ADDENDUM No. 03
DNR-220039
Delaware State Park Wastewater Treatment
April 2, 2024

2. The following additional questions have been received to date:

STATE OF OHIO
DEPARTMENT OF NATURAL RESOURCES
OFFICE OF CHIEF ENGINEER
DELAWARE STATE RESERVOIR PARK
SEWAGE TREATMENT PLANT
CONCRETE PLAN

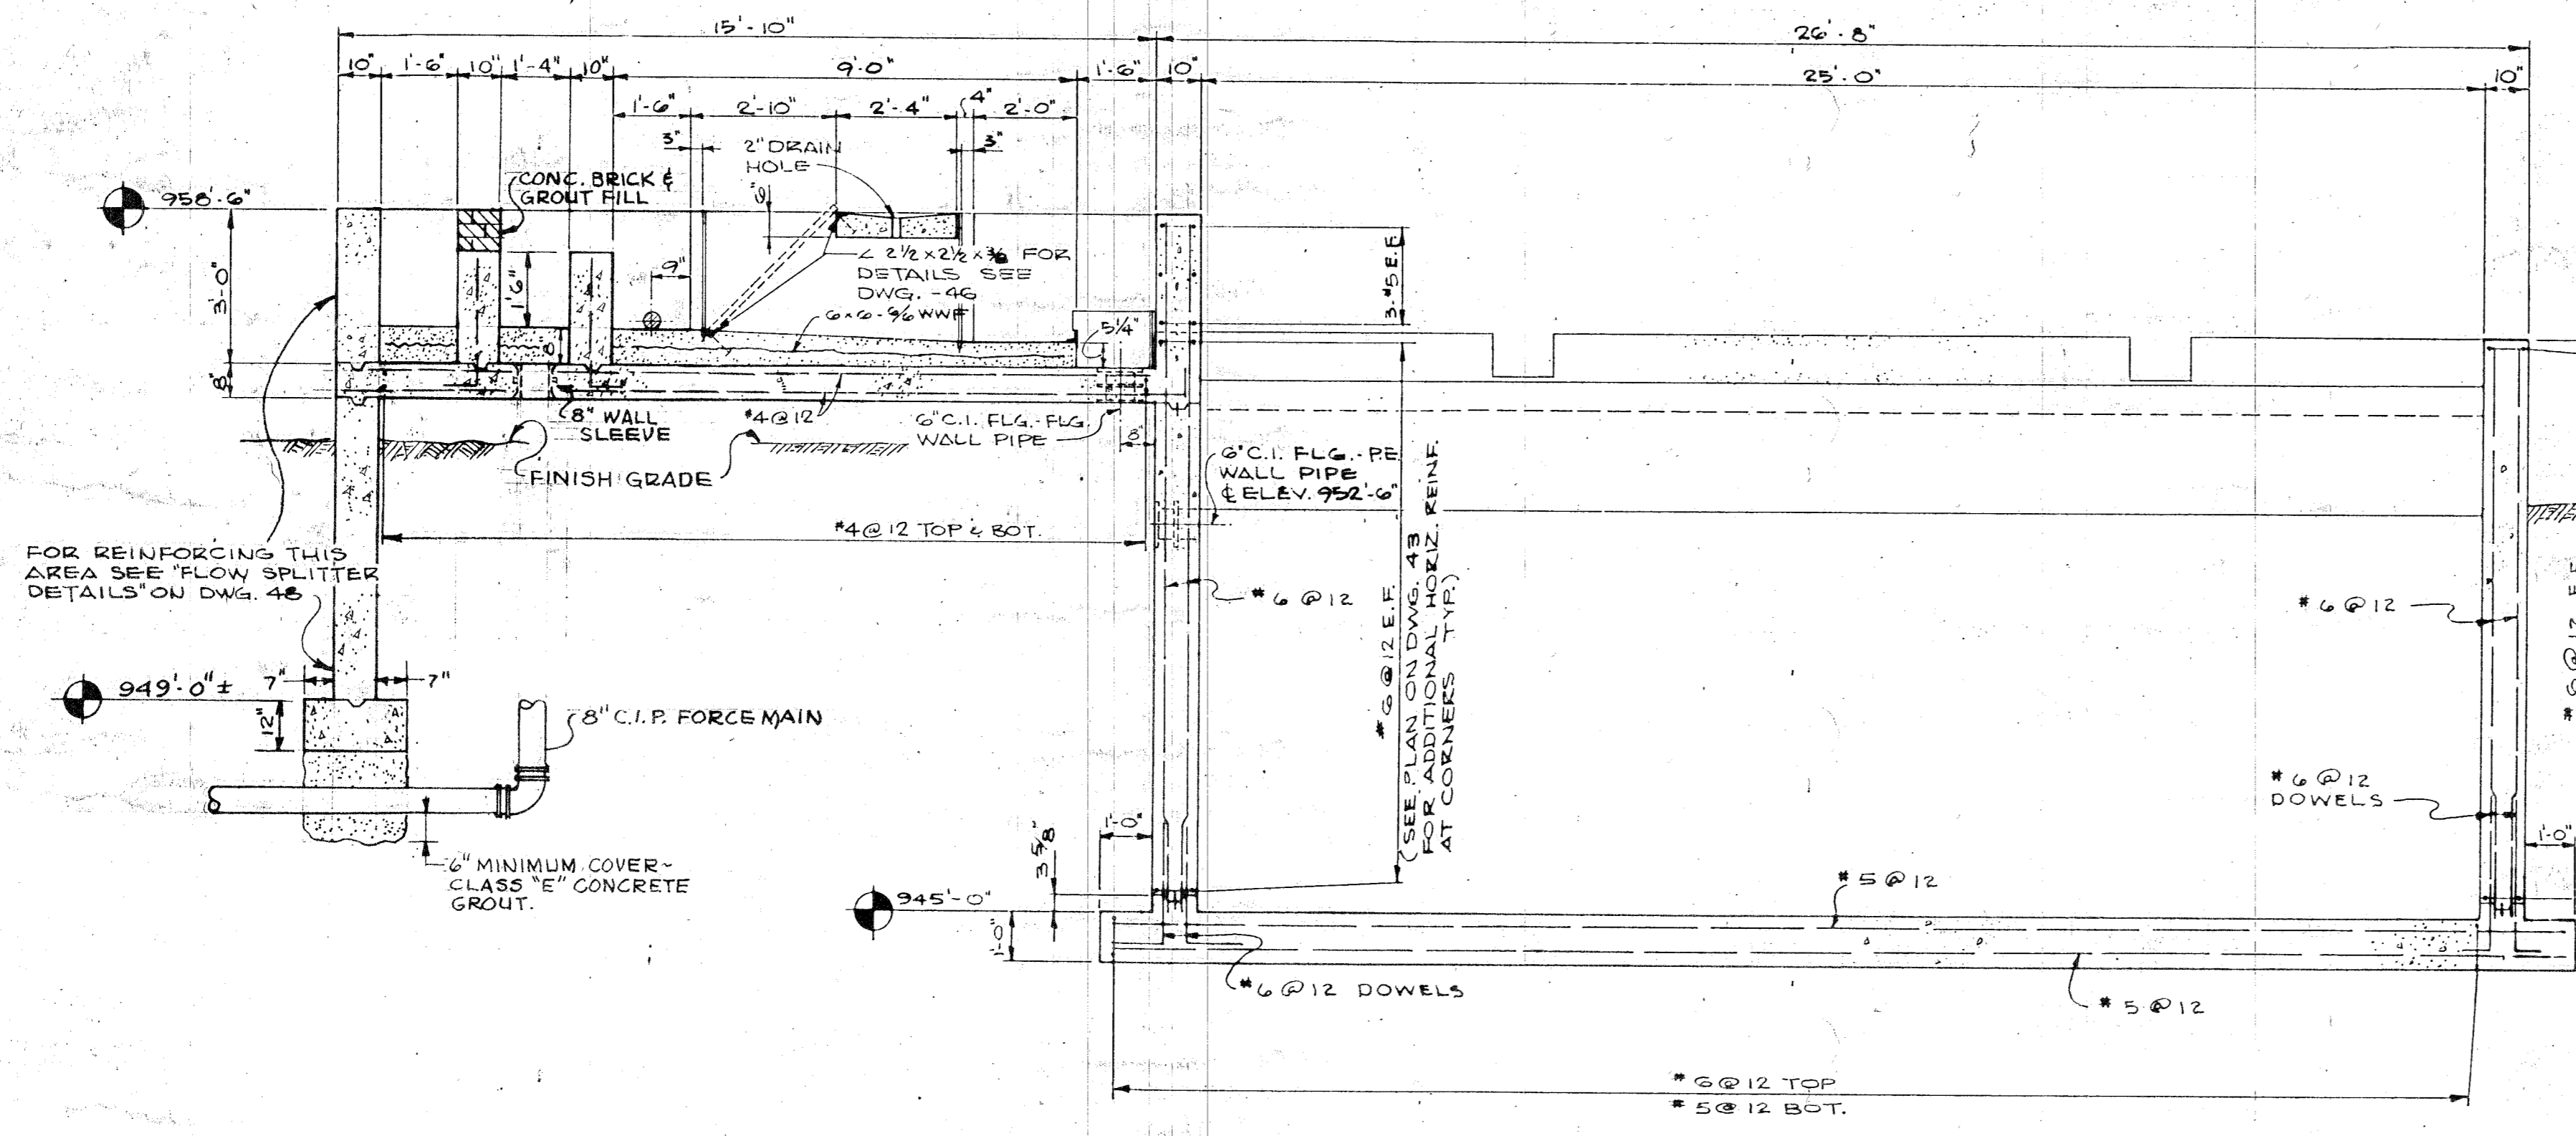
Q: Do you have the plans for the existing Plant so we can see depths and dimensions?

A: *Yes, existing plant plans that pertain are attached. Existing plant depths from top of wall to bottom of concrete (based on plans provided by ODNR); influent box (headworks) – approximately at grade; aeration tanks - approximately 12.5'; settling tank (clarifier) slopes to approximately 16.5'; chlorine contact tank – approximately 12'. The existing WWTP top of wall is approximately 2' to 3' above ground. (attached plans do not necessarily reflect as-built conditions)*
